Product Change Notification

Date Issued :	October 18, 2022	PCN Number :	512771
Reason for Change :	Equipment Transfer, Production Transfer or Rearrangement		
Description of Change :	This notification is to inform you about an equipment transfer that has been used to manufacture impacted part(s). Equipment has been moved to different site/ location/ premises. No changes will be made to product part, fit nor function as part of this change.		
Assessment of Change :	No change to parts - Form/Fit/Function Dimension analysis		
Planned Implementation Date :	April 18, 2023		
Sample Availability Date:	March 17, 2023		
Internal Molex Qualification Date :	March 17, 2023		
Last date to request Samples by Customer :	March 27, 2023		
Traceability Code Markings / Date :	Date code

Guadalajara 2

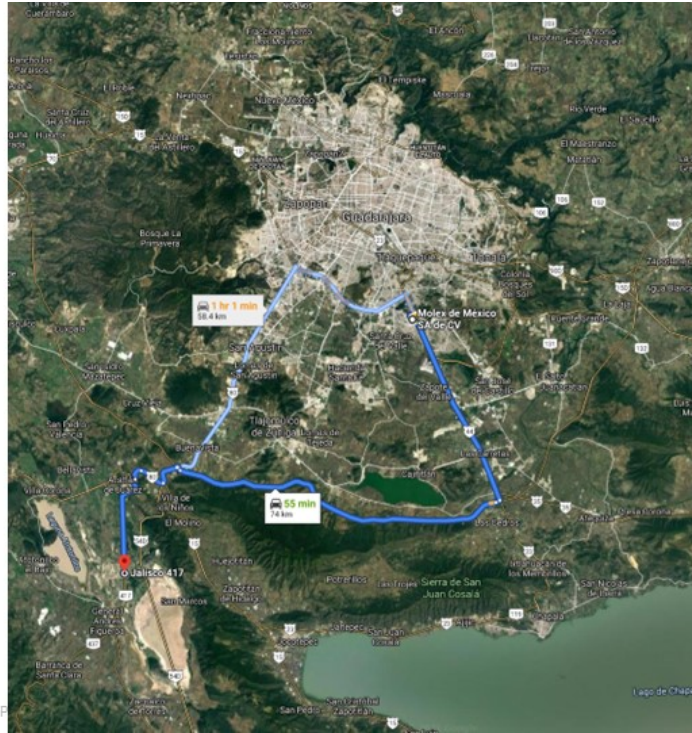
- Located in Centro Logistico Jalisco Industrial Park
- 1 hour from existing Guad1
- Initial build will contain Molding, Assembly, and Reliability Testing capabilities
- A new Distribution Center services Guad2
